Overheating Risk Assessment

Land North of Arundel Road, Fontwell

For Harlequin Developments

Appendix D – Overheating markups

Drawing Title
Floor Plans and Elevations - HT05 Semi

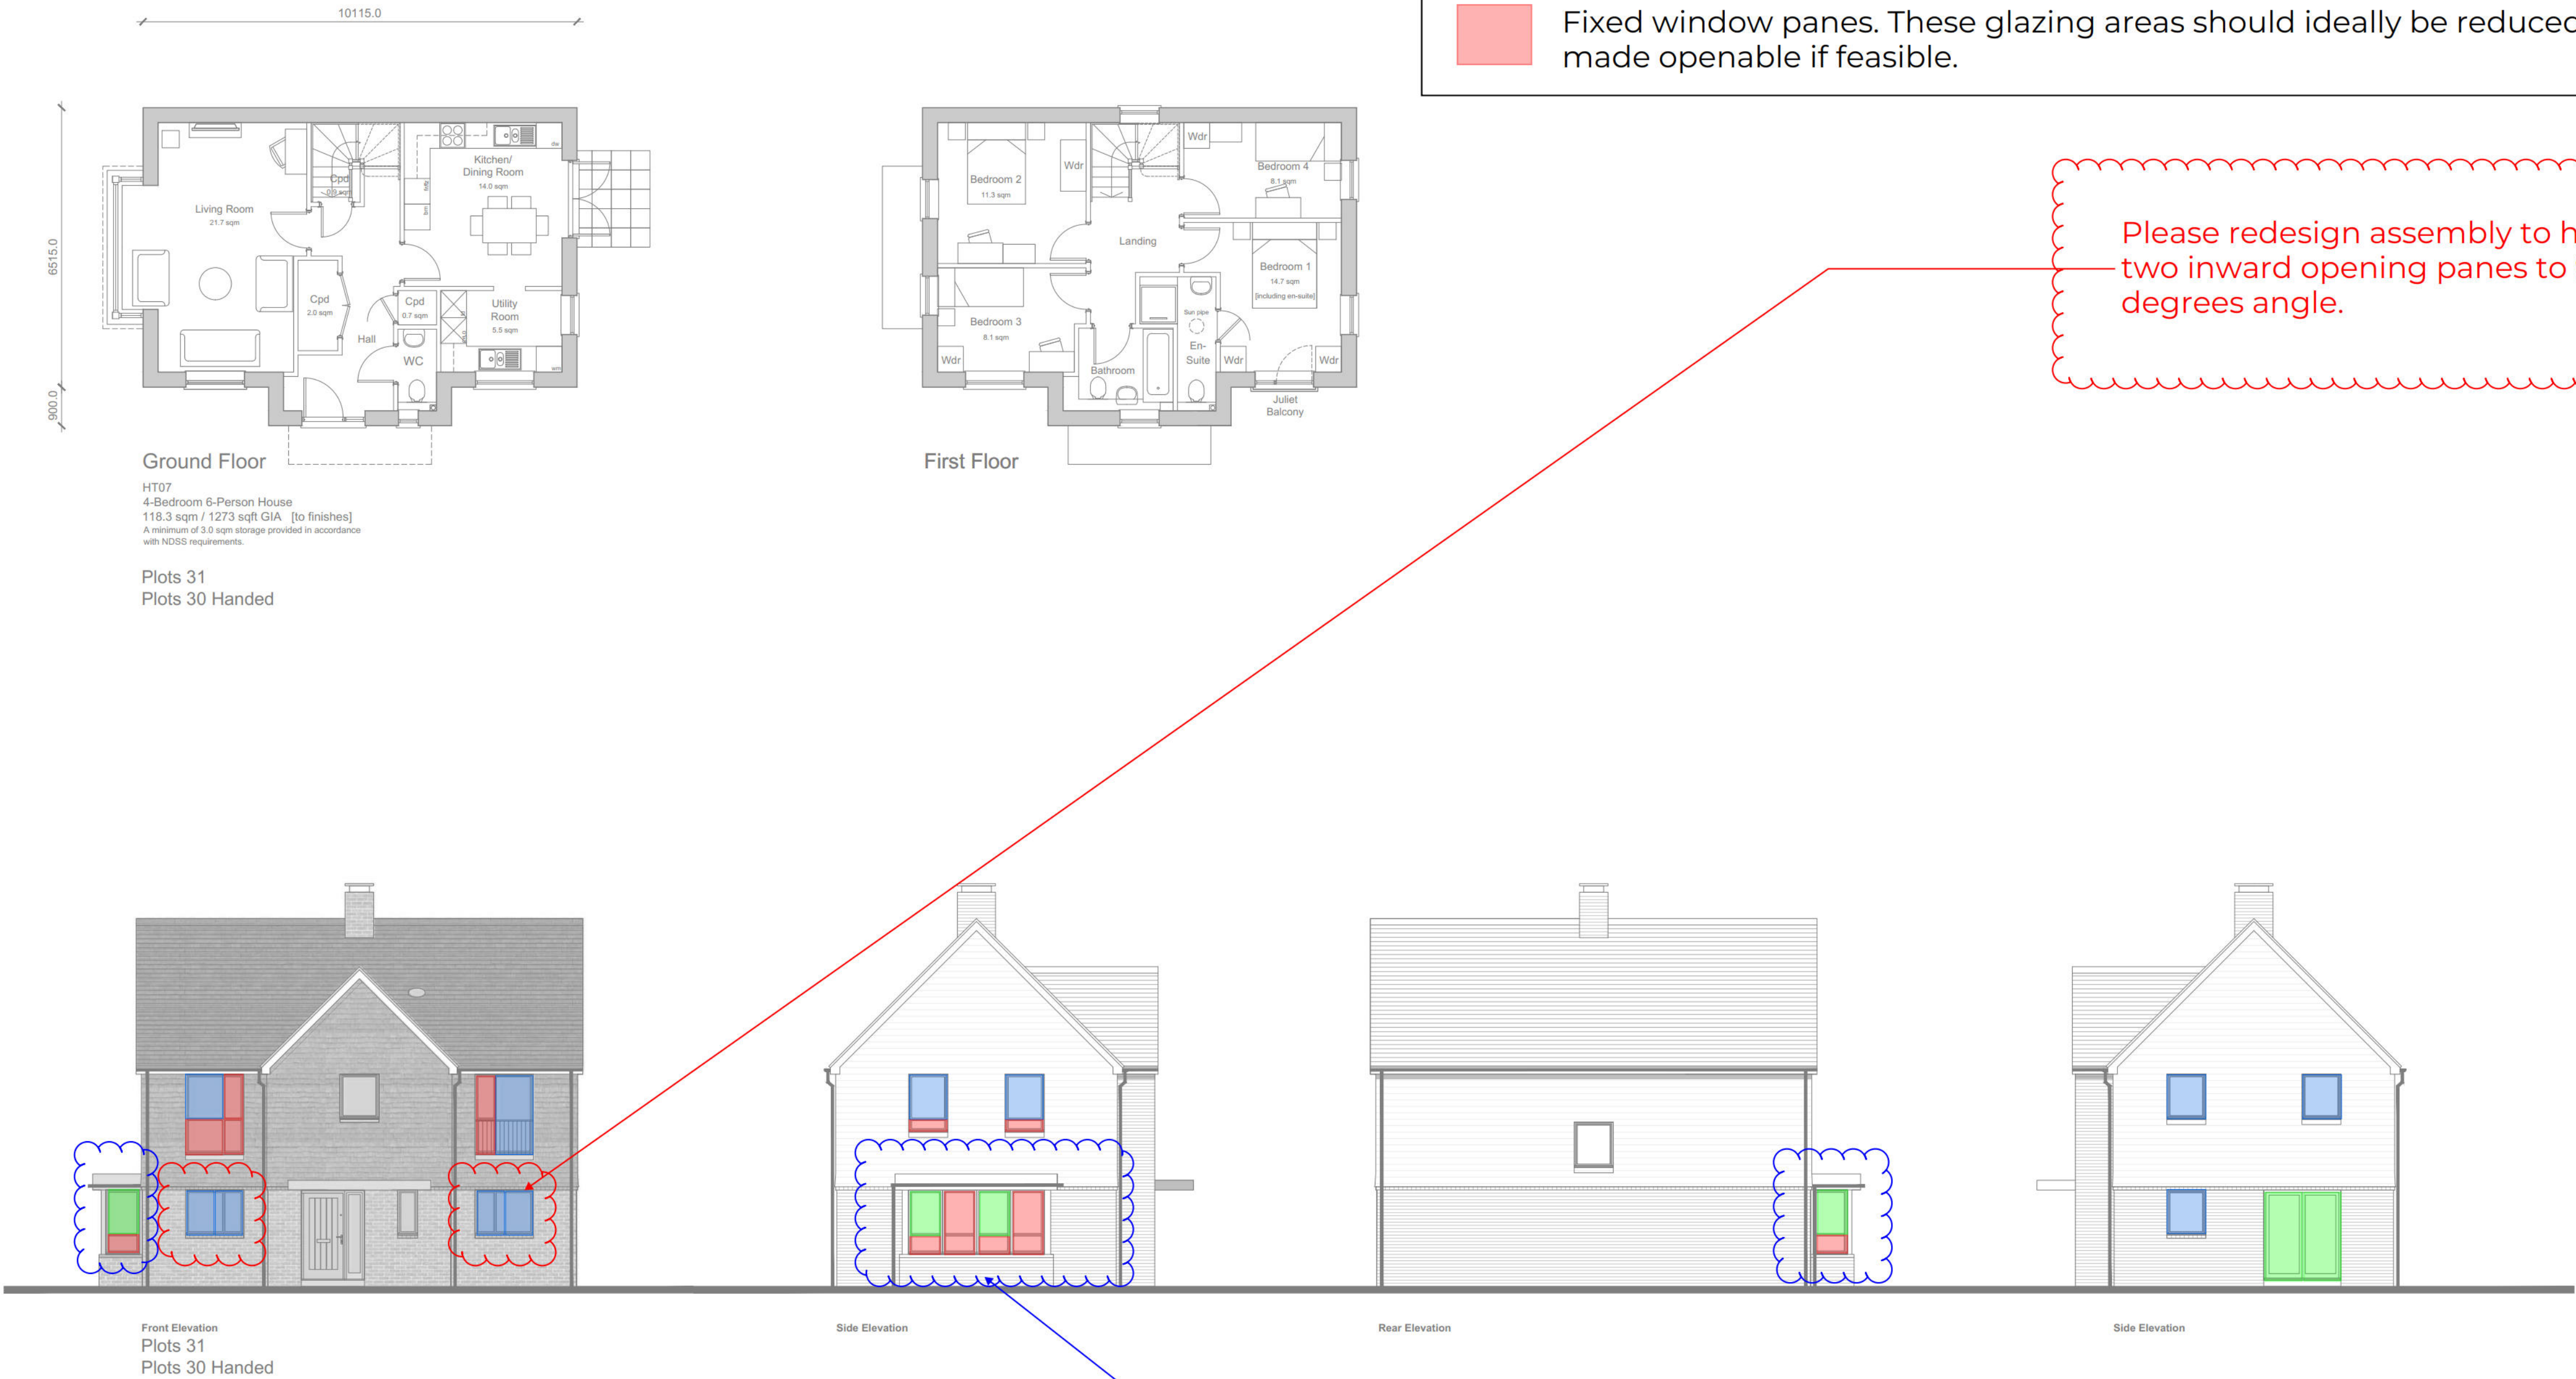
1) Please review transom or bottom of window heights for all window assemblies on upper floors where there is risk of falling. Part O (2021) guidance requires transoms to be at 1.1m above FFL to enable openable windowpanes above the transom to be fully openable. From our review of section drawings, the scheme is compliant but ECE please confirm.

2) All windows to have a g-value of 0.4.

3) For plots where bedrooms do not deviate from ADO noise criteria:

Please ensure all Ground Floor (GF) Kitchen, Living, Dining (KLD) spaces can achieve a small opening (circa 0.1m² unobstructed free area per room) to provide night-time ventilation securely.

5) Current assessment based on ADO (2021) and CIBSE TM59 (2017). Final strategy to be confirmed based on ADO calculations to be carried out at detailed design and construction stages post-planning with the applicable guidance and regulations at the time of detailed design and construction stages.

Drawing Title
Floor Plans and Elevations - HT03 Semi

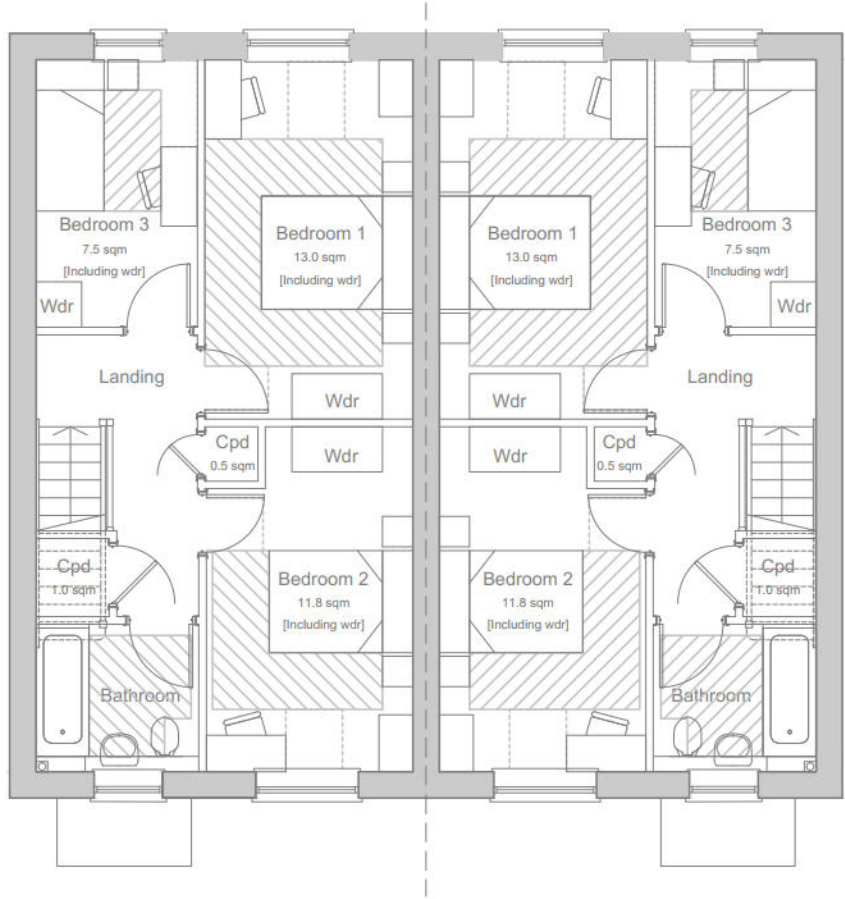
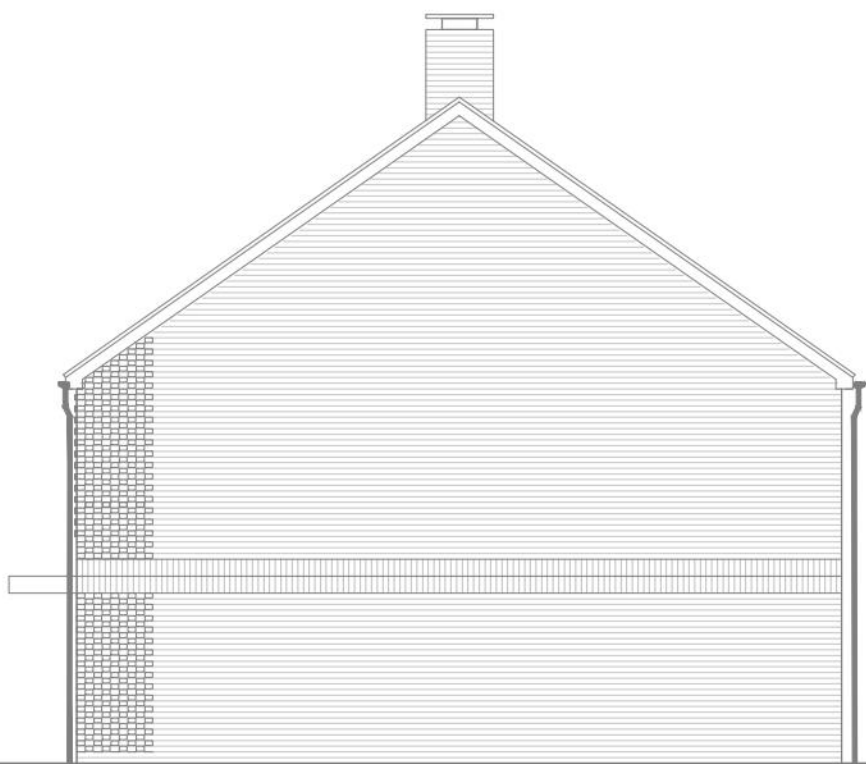
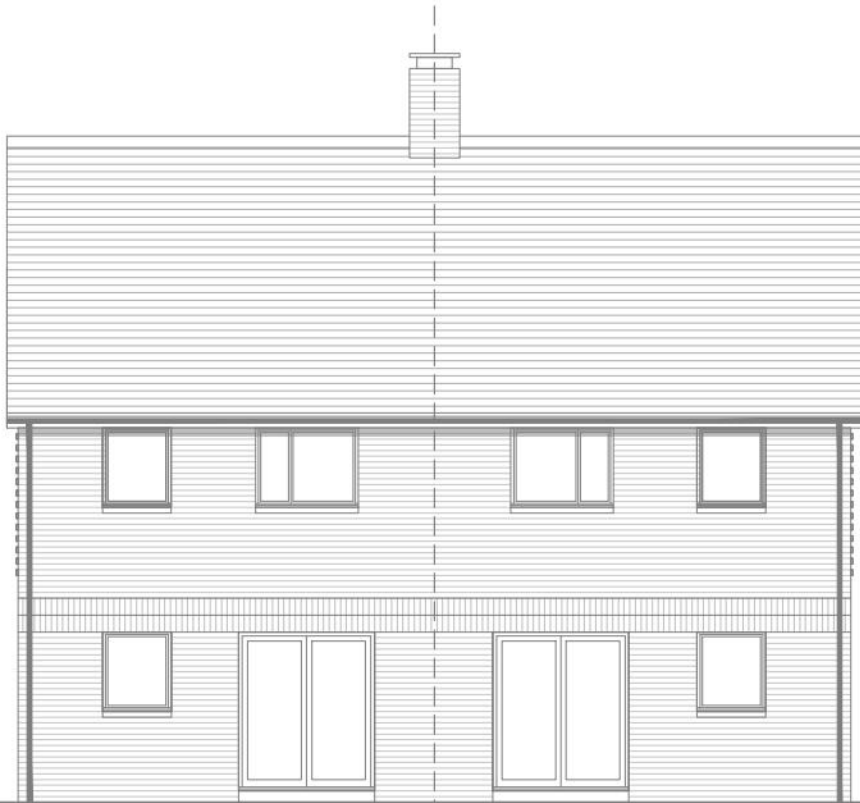
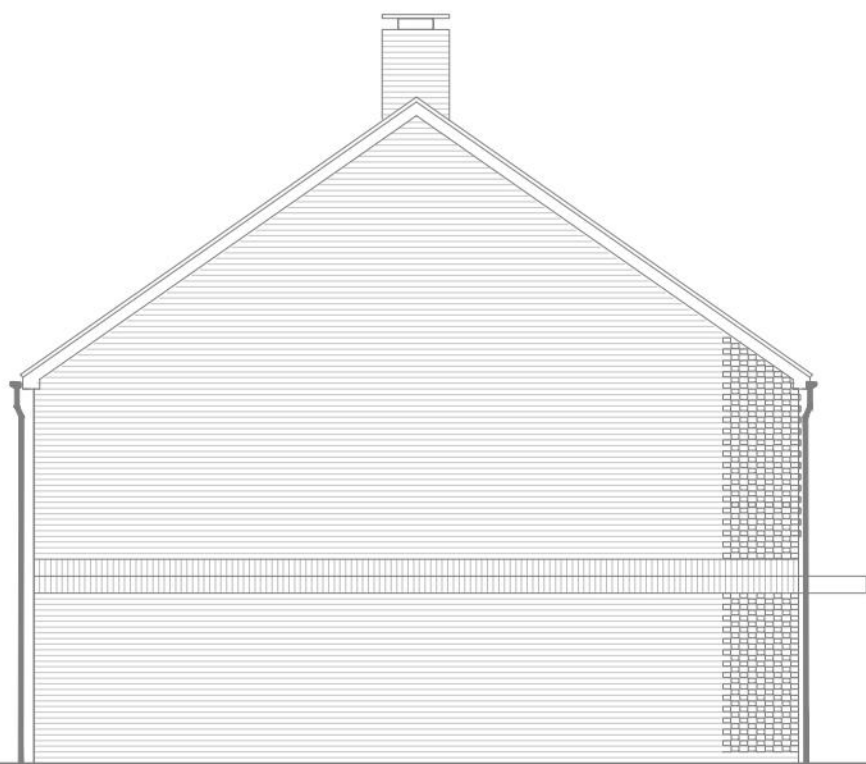
Please refer to previous pages for guidance on how to design the window assemblies of this typology.

Drawing Title
Floor Plans and Elevations -HT02B Semi

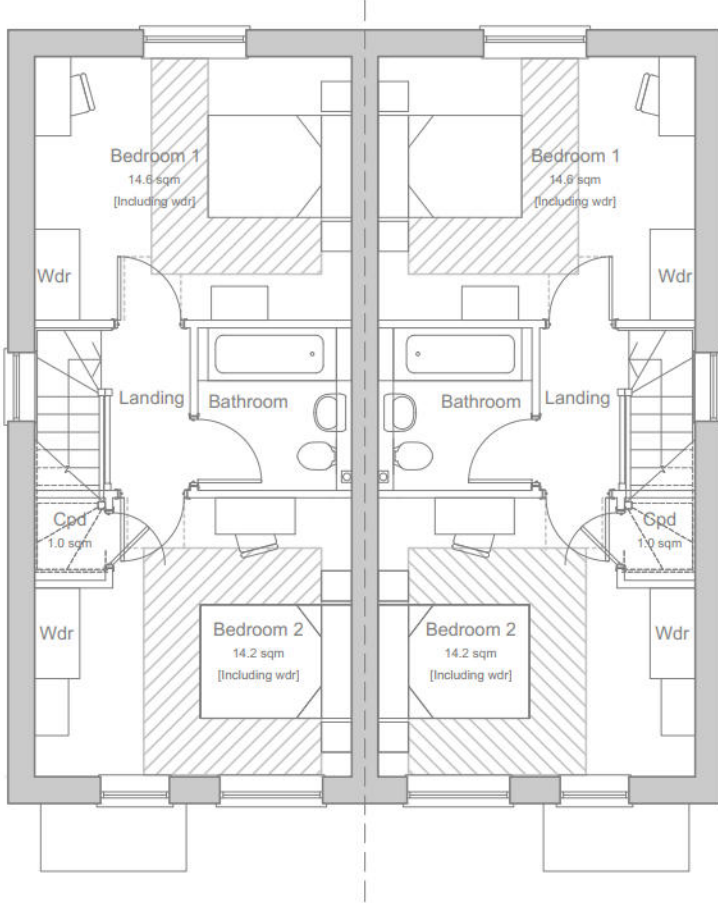
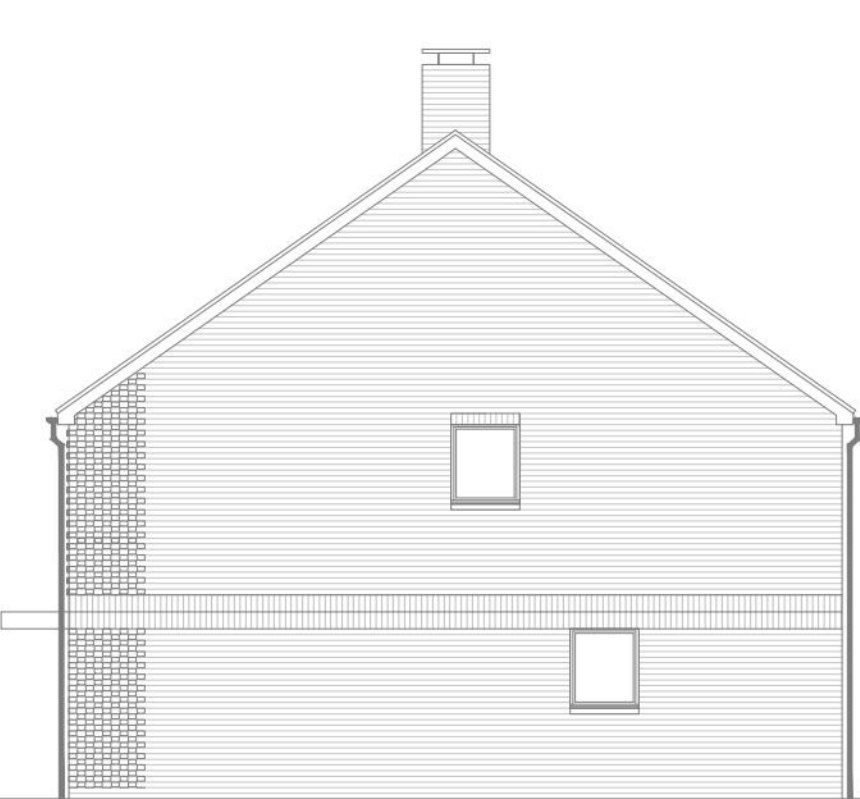
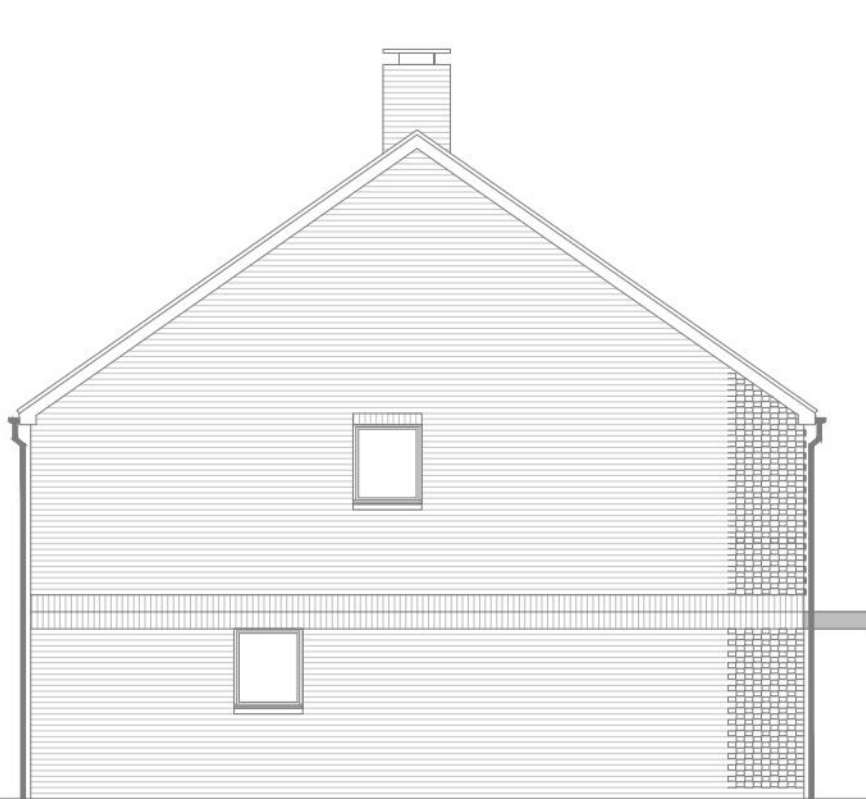
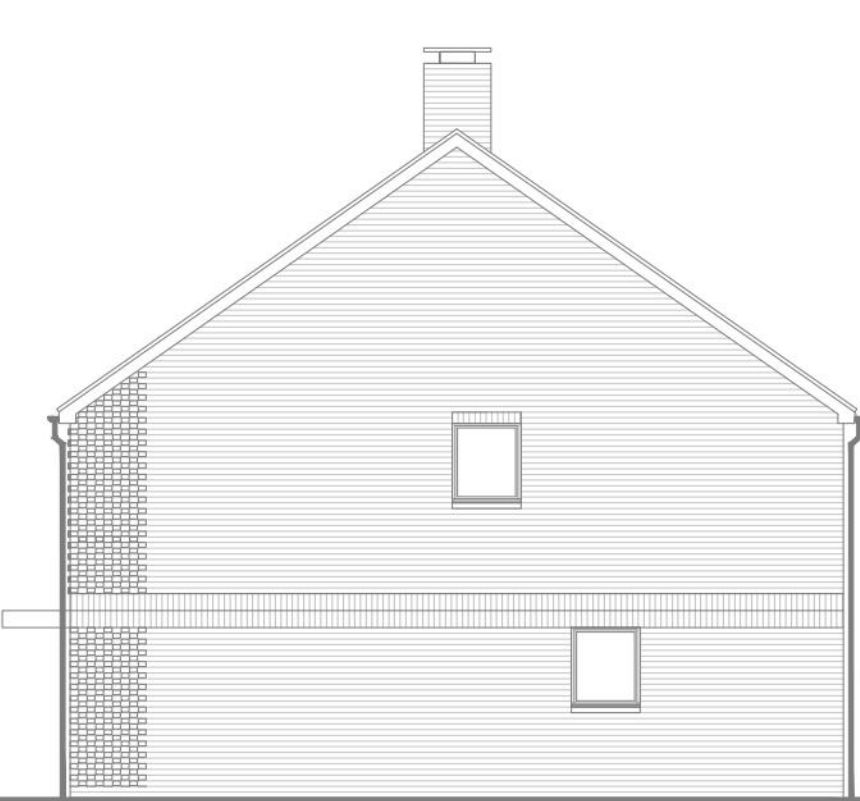
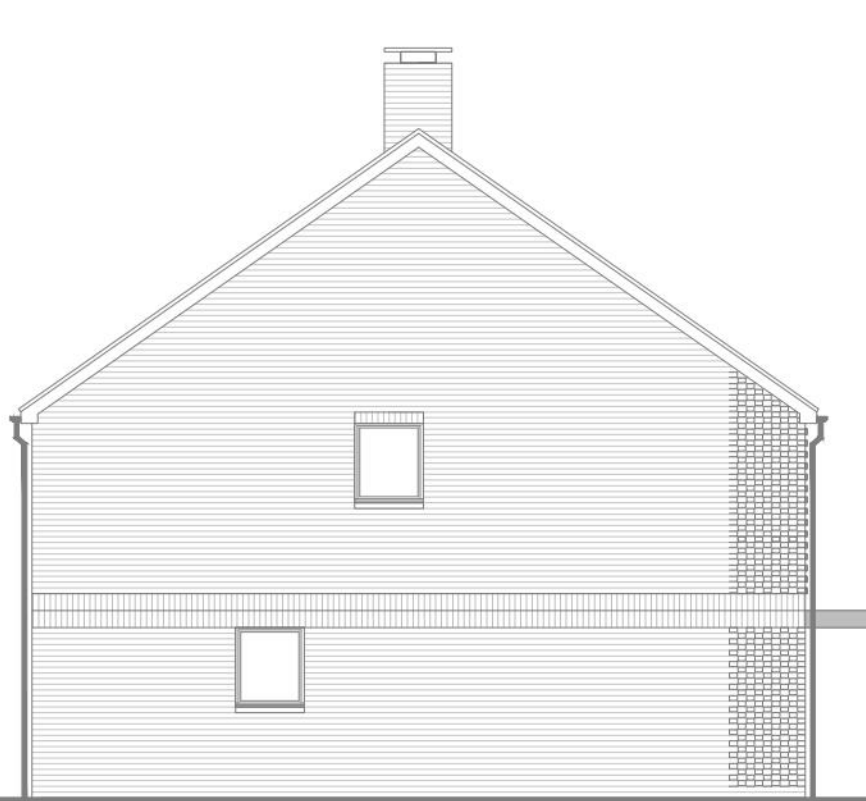
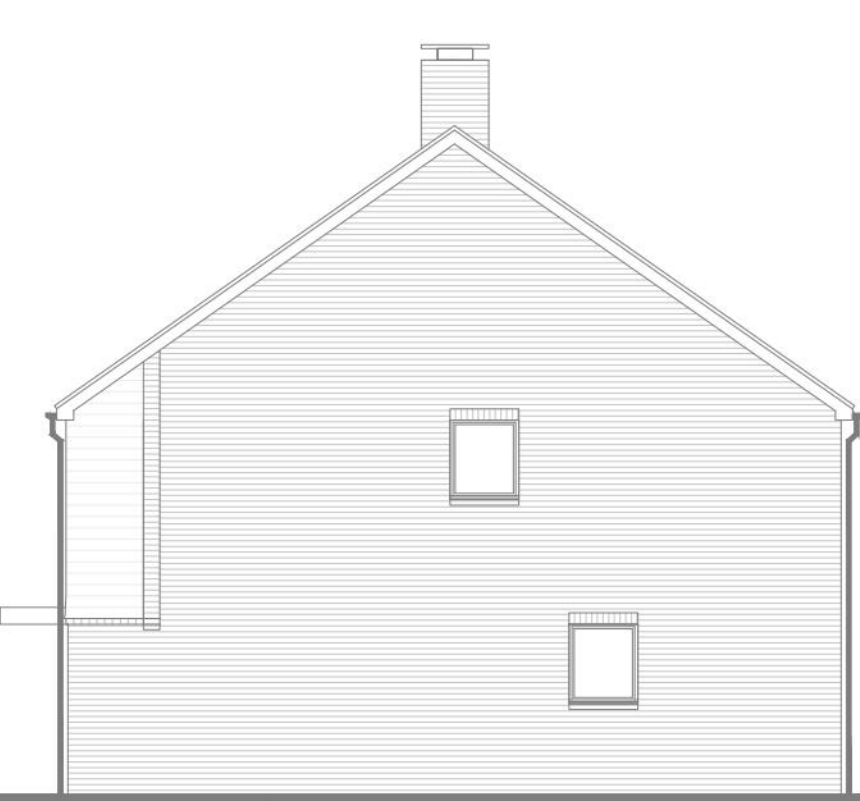
Please refer to previous pages for guidance on how to design the window assemblies of this typology.
